THE NATIONAL BOARD OF BOILER AND PRESSURE VESSEL INSPECTORS

NATIONAL BOARD INSPECTION CODE COMMITTEE

MINUTES

Meeting of January 11th, 2018
New Orleans, LA

INTERPRETATION 95-21

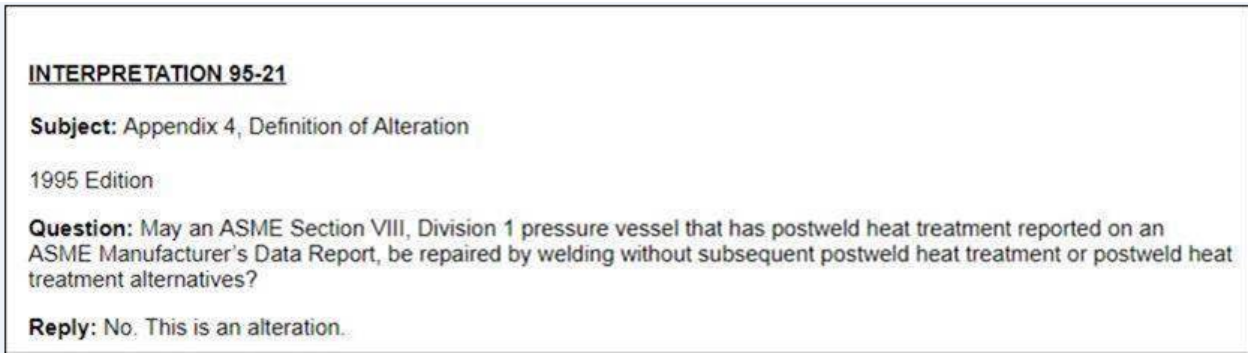
Question: May an ASME Section VIII, Division 1 pressure vessel that has postweld heat treatment reported on an ASME Manufacturer's Data Report, be repaired by welding without subsequent postweld heat treatment or postweld heat treatment alternatives?

Reply: No. This is an alteration.

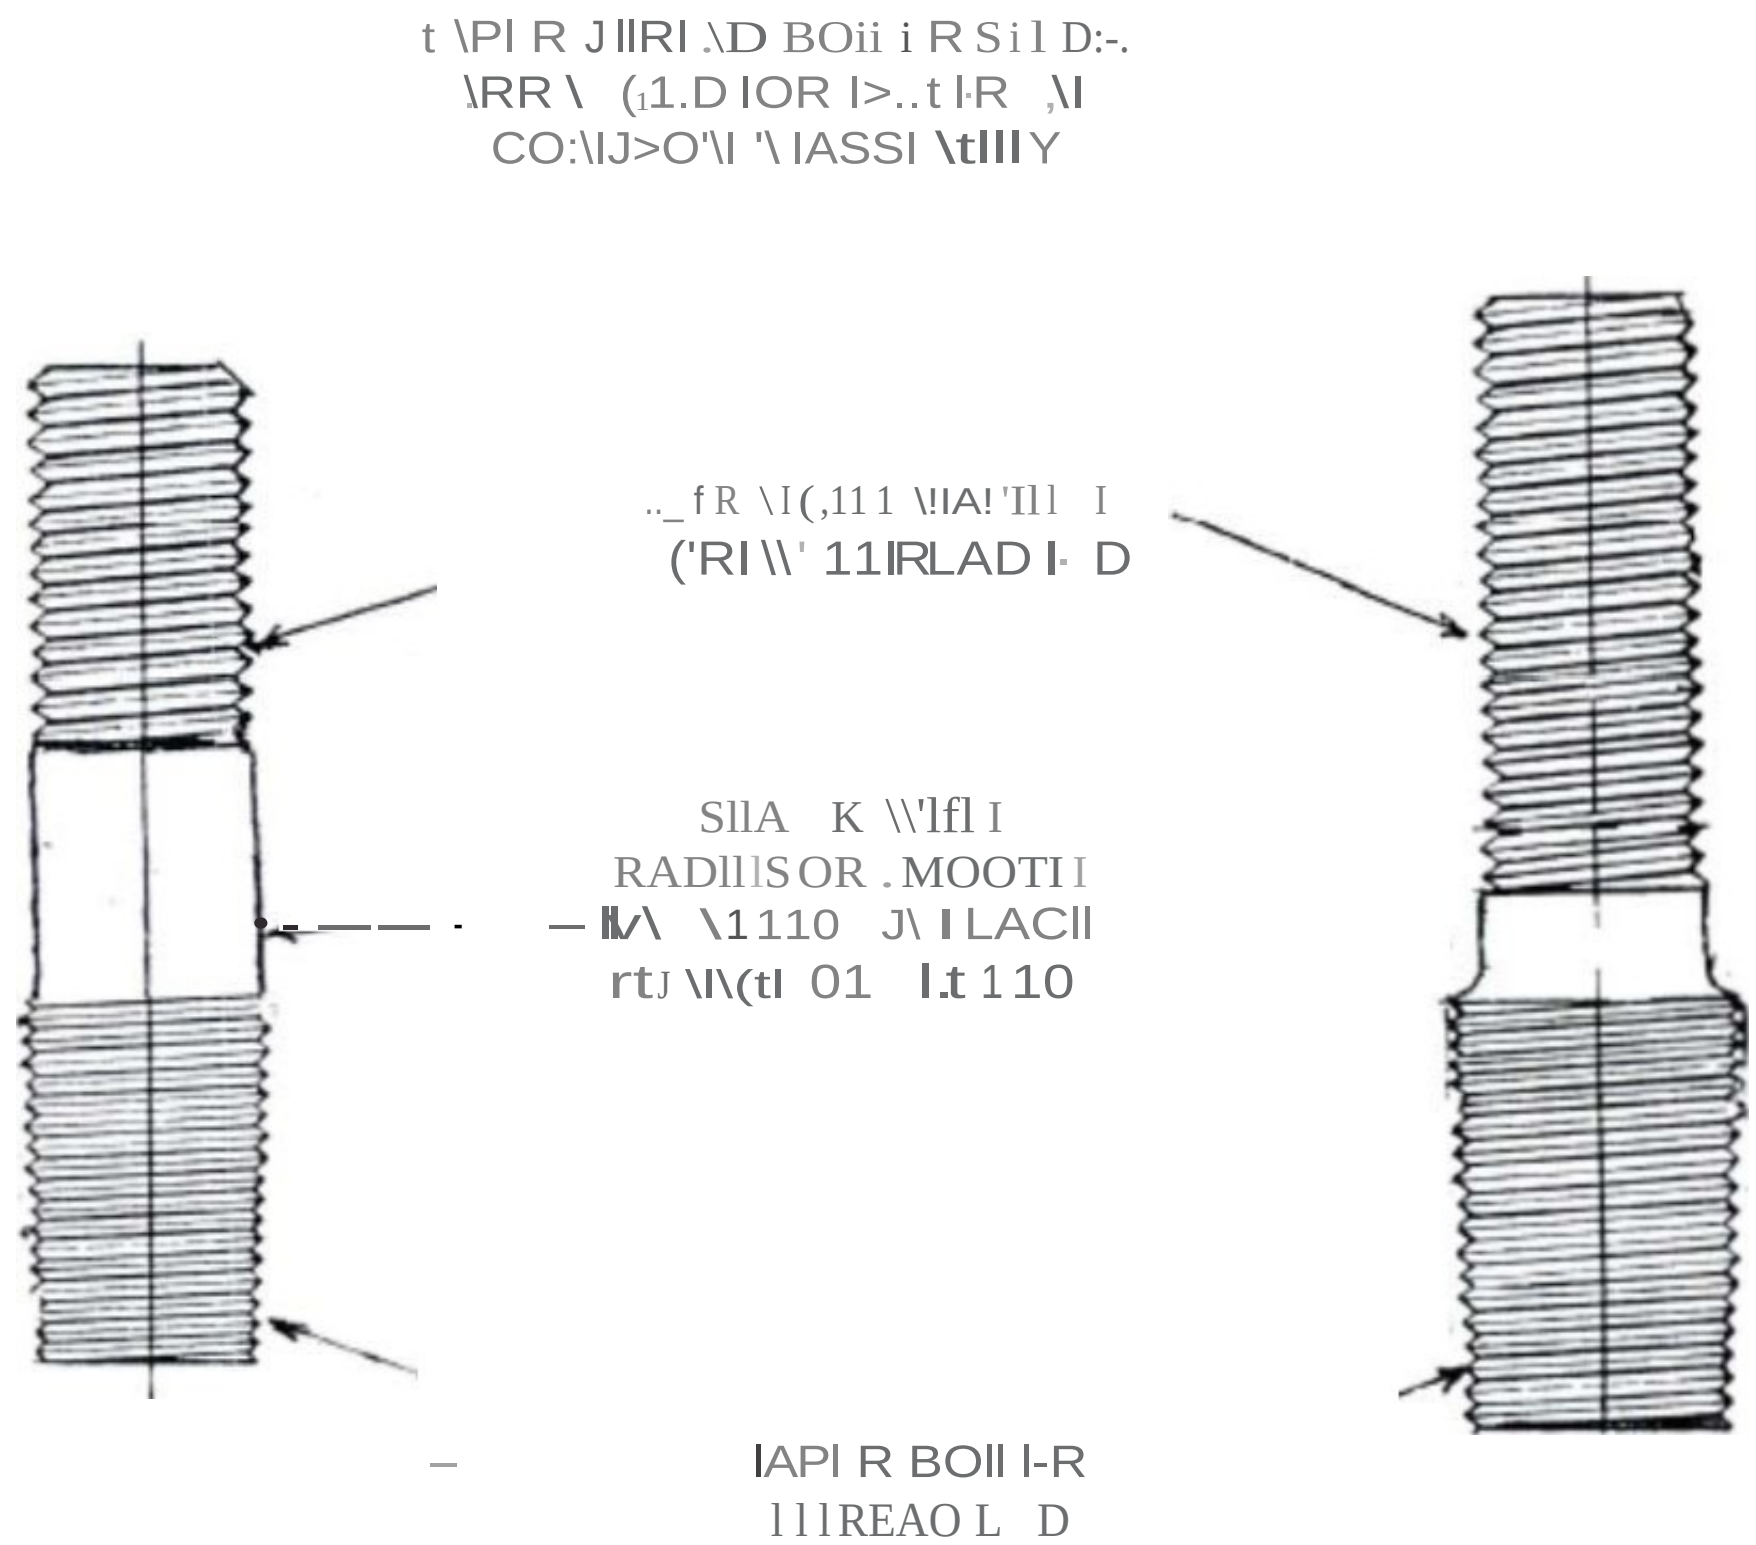
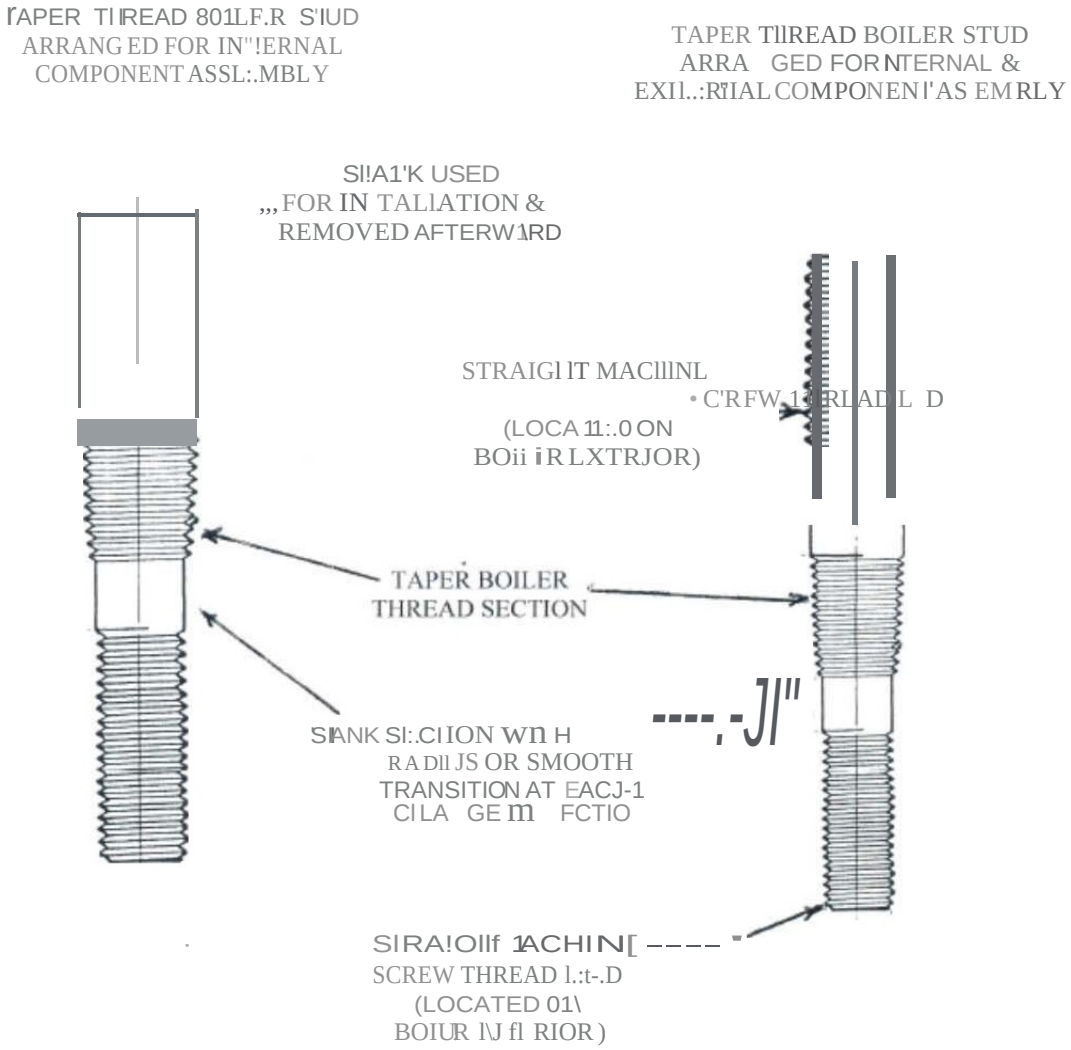
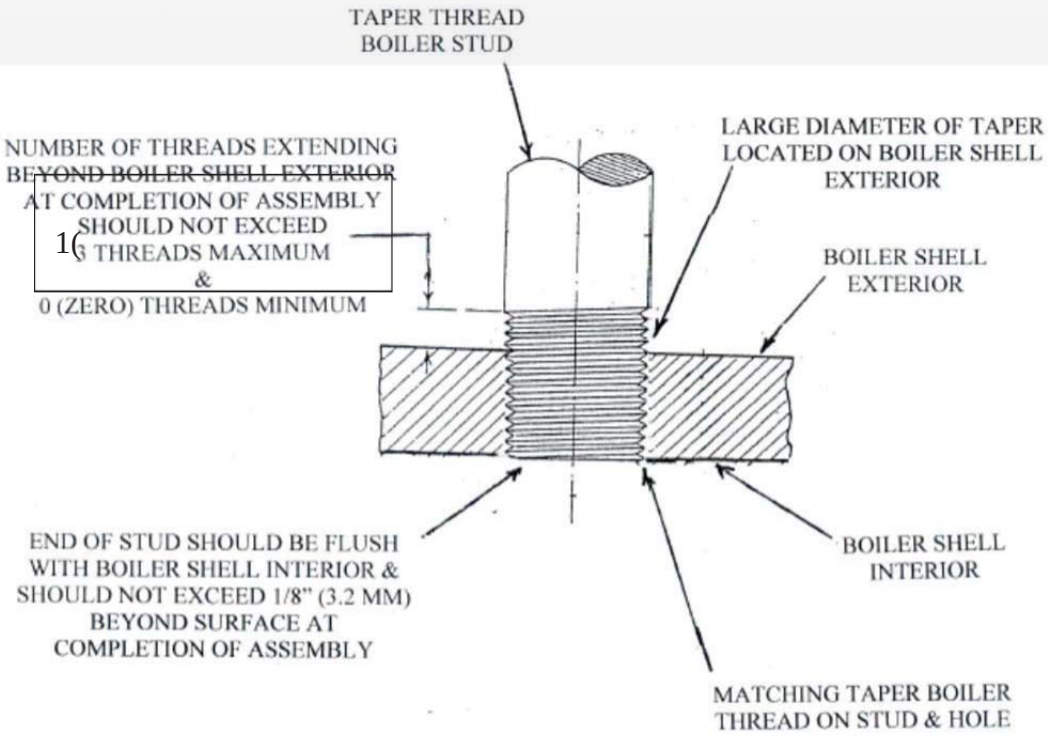
Revised title and section: **S1.2.7.2 TAPER THREAD BOILER STUDS (SEE NBIC PART 3, FIGURES S1.2.7.2-a, S1.2.7.2-b & S1.2.7.2-c)**

b) When taper thread boiler studs are installed into blind holes on the boiler shell or sheet the taper section length shall be confirmed to be shorter than the hole depth in order to prevent the stud from contacting the hole bottom upon being tightened at final assembly.

INTERPRETATION 95-21

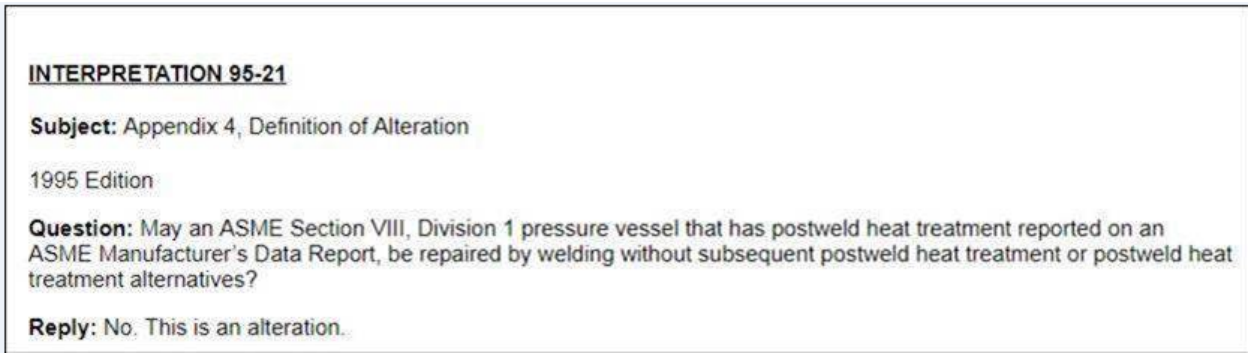
Rational: Reference Interpretation 95-21

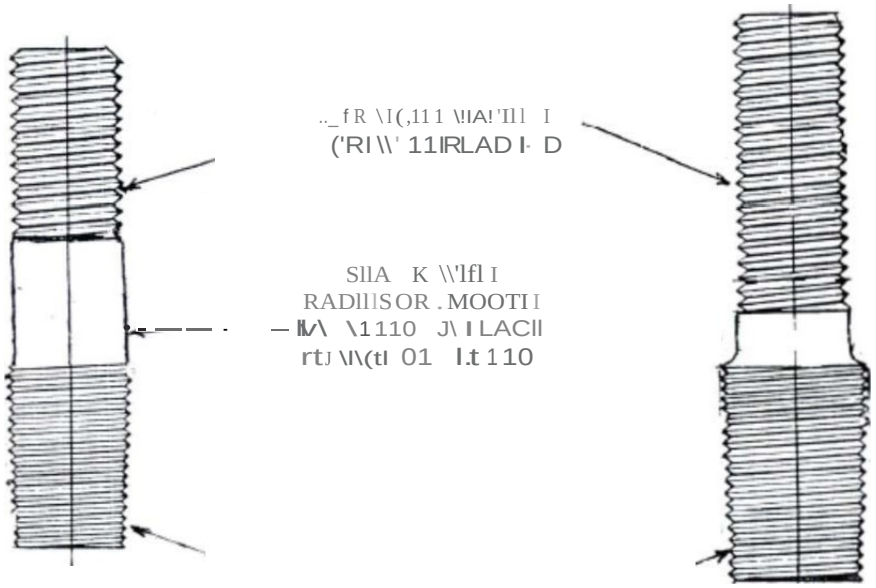
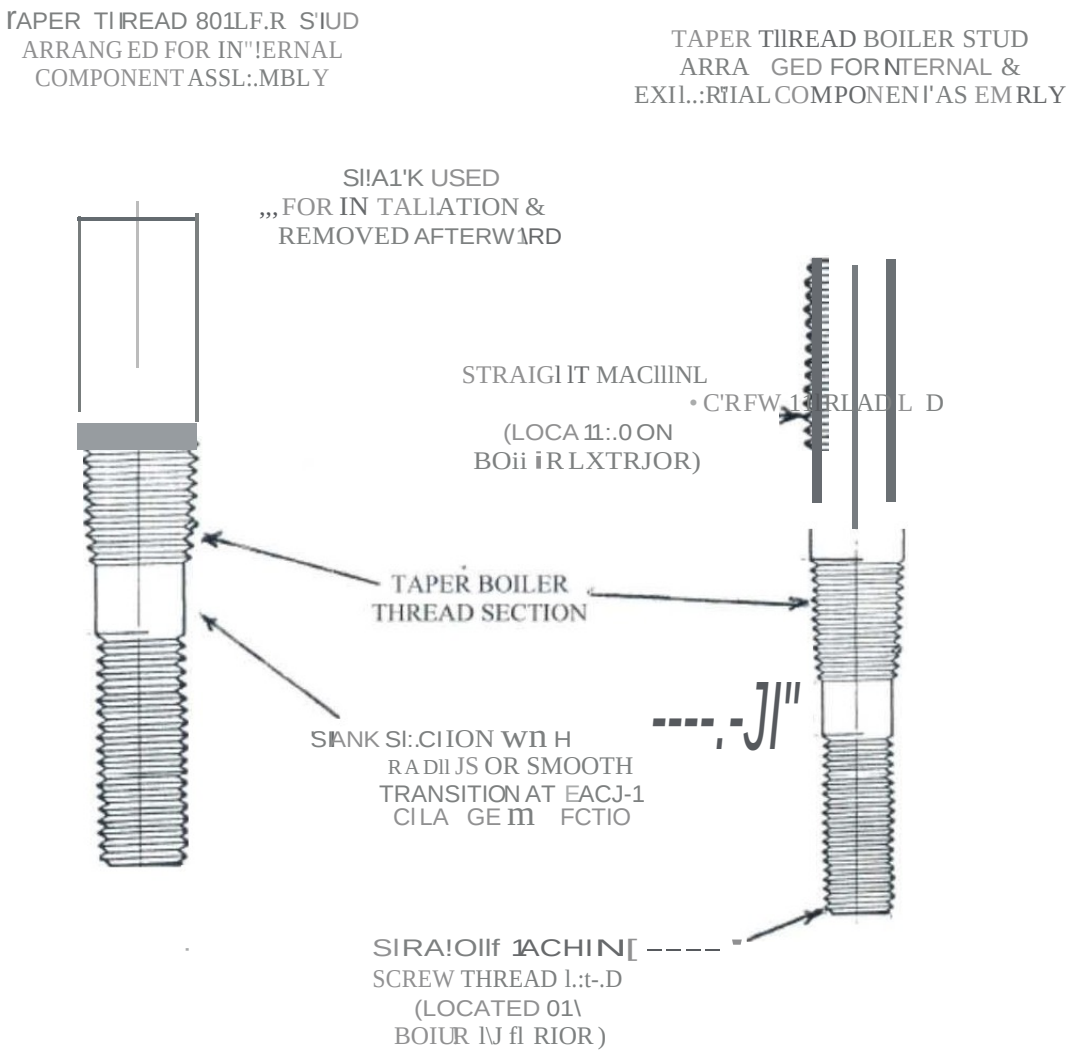
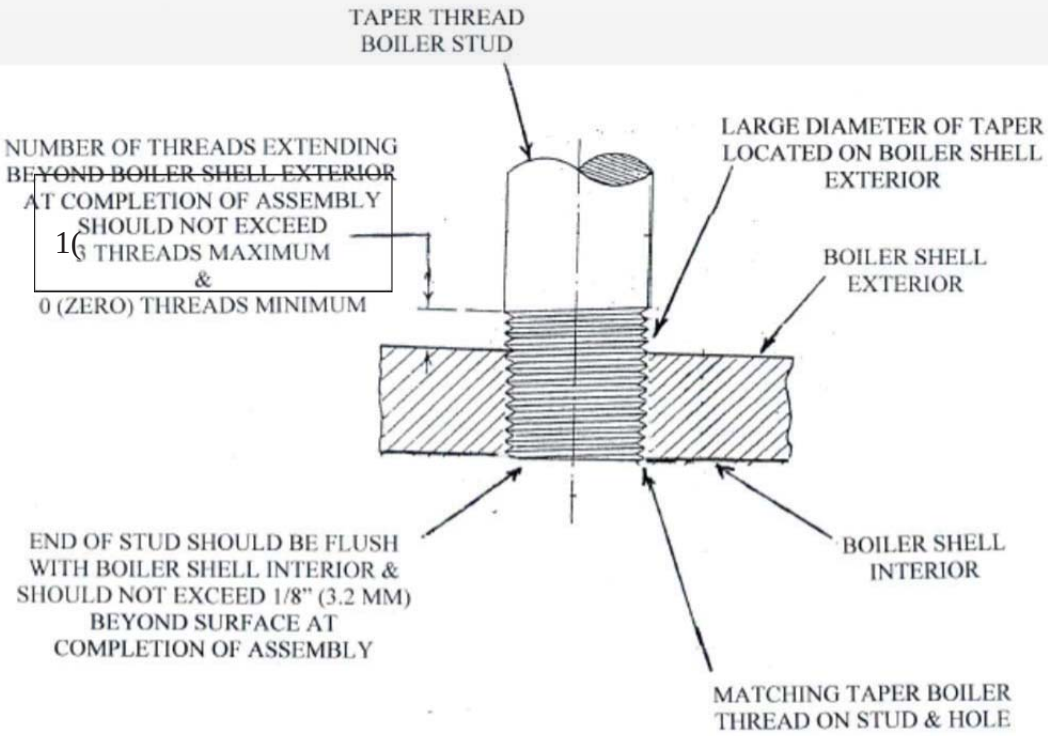
Revised title and section: **S1.2.7.2 TAPER THREAD BOILER STUDS (SEE NBIC PART 3, FIGURES S1.2.7.2-a, S1.2.7.2-b & S1.2.7.2-c)**
